MILLER'S POND DAM

NDI No. PA 01004
PennDER No. 8-27
Dam Owner: Ernest Weaver

PHASE I INSPECTION REPORT
NATIONAL DAM INSPECTION PROGRAM

June 1981

**FIELD SKETCH****MILLER'S POND DAM**

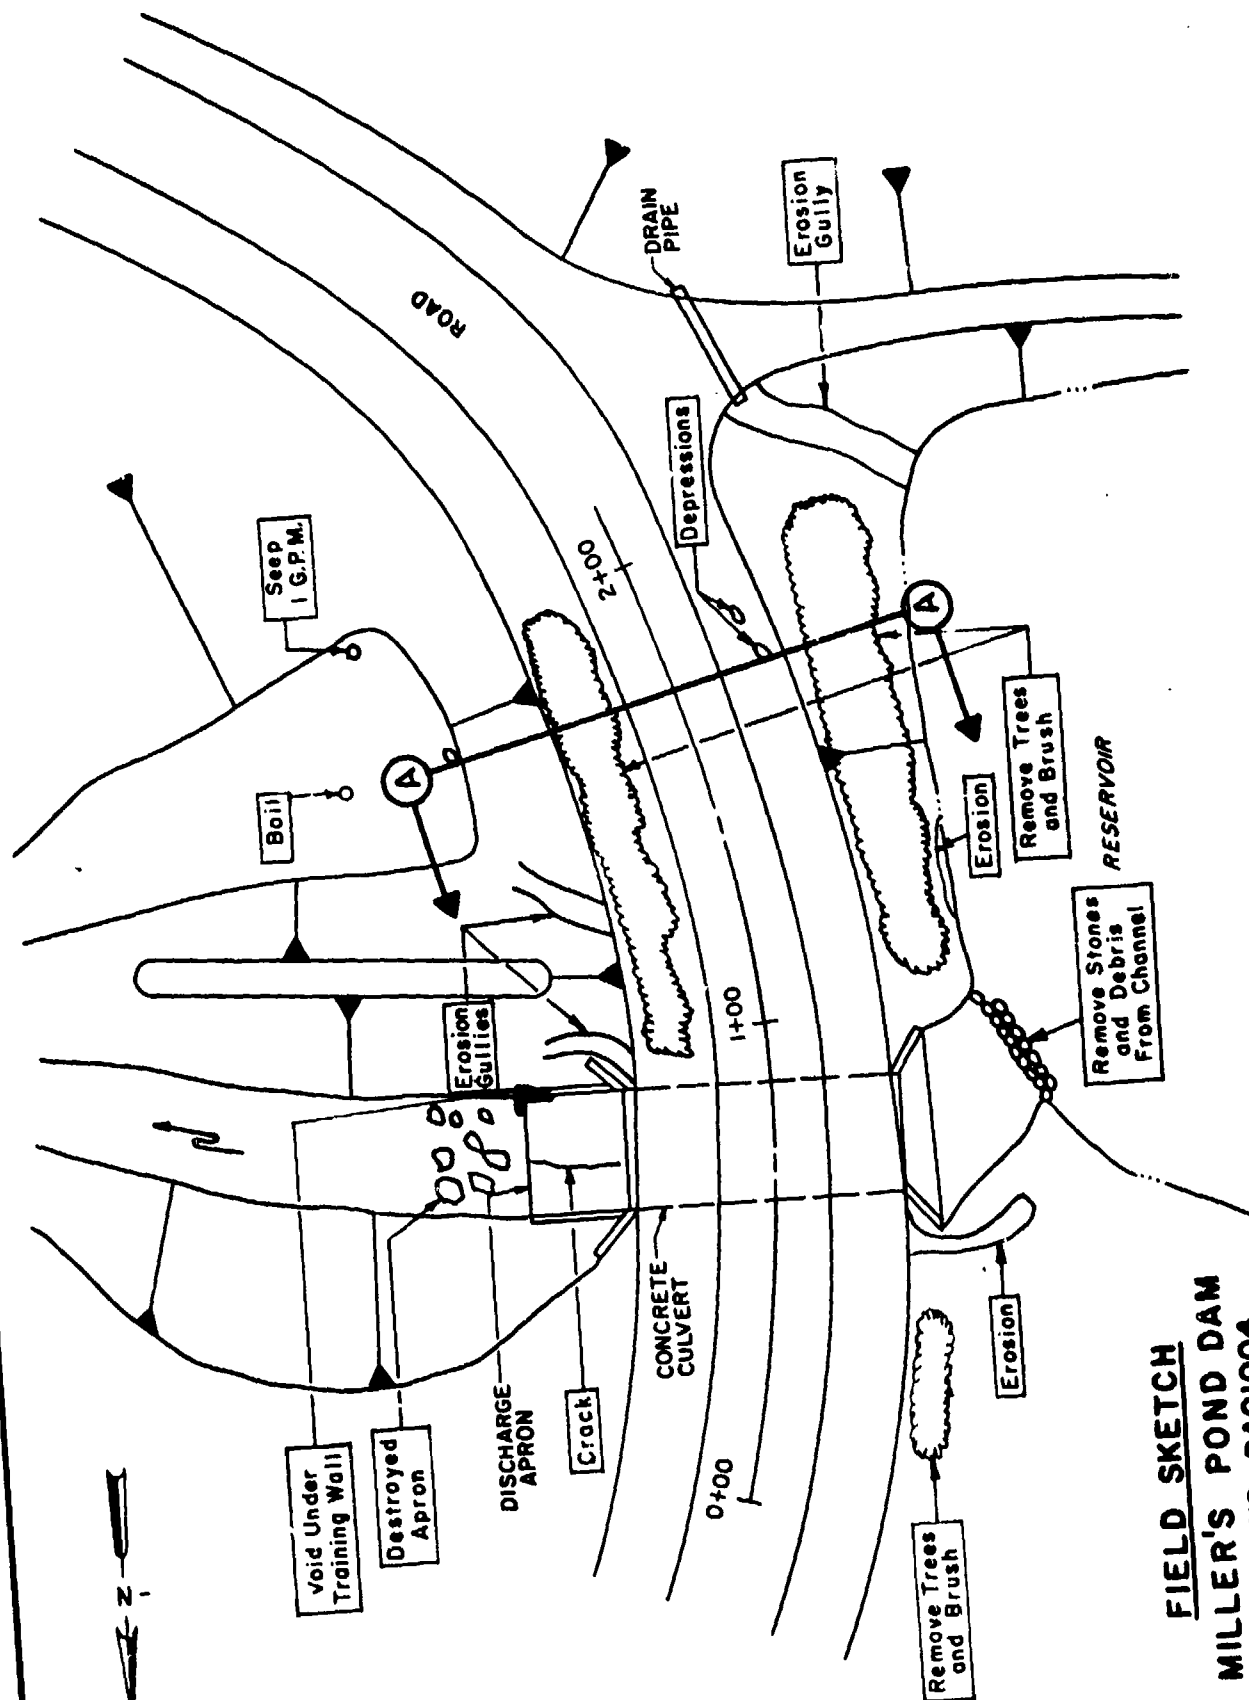
- b. Dam - Two seeps were observed at the downstream toe of the dam, and one boil was observed approximately 20 feet beyond the toe of the dam (see Field Sketch in Appendix A). A depression 3 feet in diameter and 2 feet deep and a 6-inch diameter depression were observed on the upstream crest. Trees and brush are growing on the upstream and downstream slopes of the embankment.

There is an eroded area behind
 and below the left side of the
 culvert wing wall on the upstream
 side of the embankment. There is
 an eroded area behind the right
 downstream culvert wing wall.

The discharge apron is destroyed. There are voids under right remaining downstream training wall. The left downstream abutment soils are capable of liquifying when fully (super) saturated.

There is evidence that clay pipe underdrains under apron. The concrete slab at culvert has dropped 2" near end and may have started to be undermined. There is major erosion in the downstream discharge channel.

- 1) Monitor the two areas of seepage at regular intervals and during periods of high reservoir levels for turbidity and/or increase in flow, which may indicate potential for the piping of embankment material. If turbidity or increased flows are noted, a qualified geotechnical engineering firm should be retained to recommend remedial measures.
- 2) Fill, compact, and seed the depressions on the crest of the dam.
- 3) Cut all trees and brush on the embankment at ground level. All trees with a trunk diameter greater than 3 inches should have their root

- 4) Clear the spillway approach channel of all debris and provide with erosion protection.
- 5) Repair the discharge apron and training walls.
- 6) Fill and seed the areas of erosion behind the wingwalls.
- 7) Protect the channel immediately downstream from the embankment with erosion protection.
- 8) Provide means to draw down the reservoir during an emergency.

PHOTO 7. View of Spillway (Culvert)
Note: Approximately Two Inch Vertical Separation at Joint

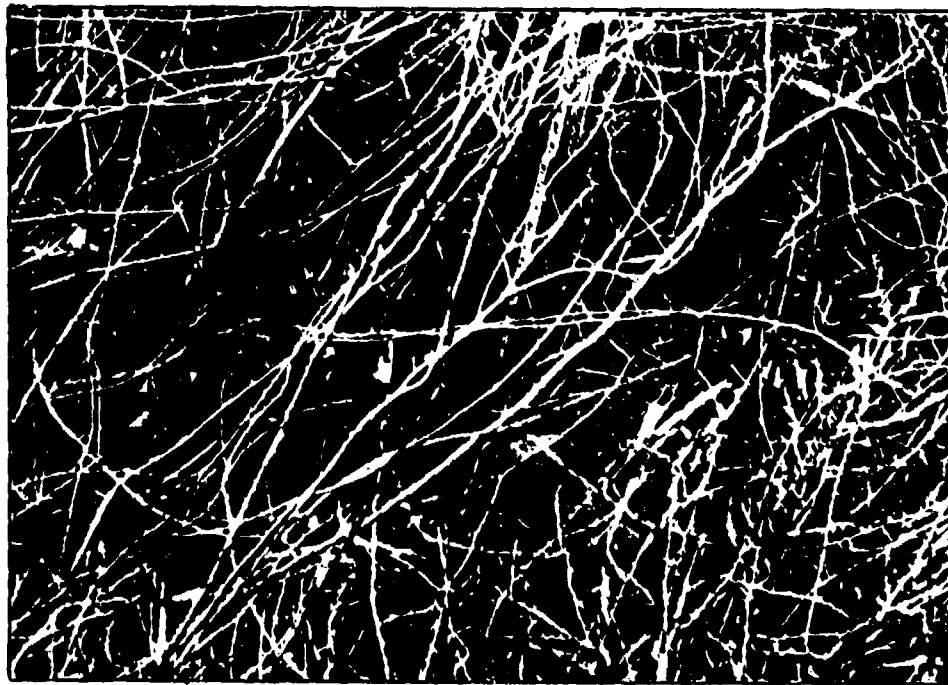
There is a joint open on the sides of the culvert. There are two spots on soffit where minor seepage is coming through.
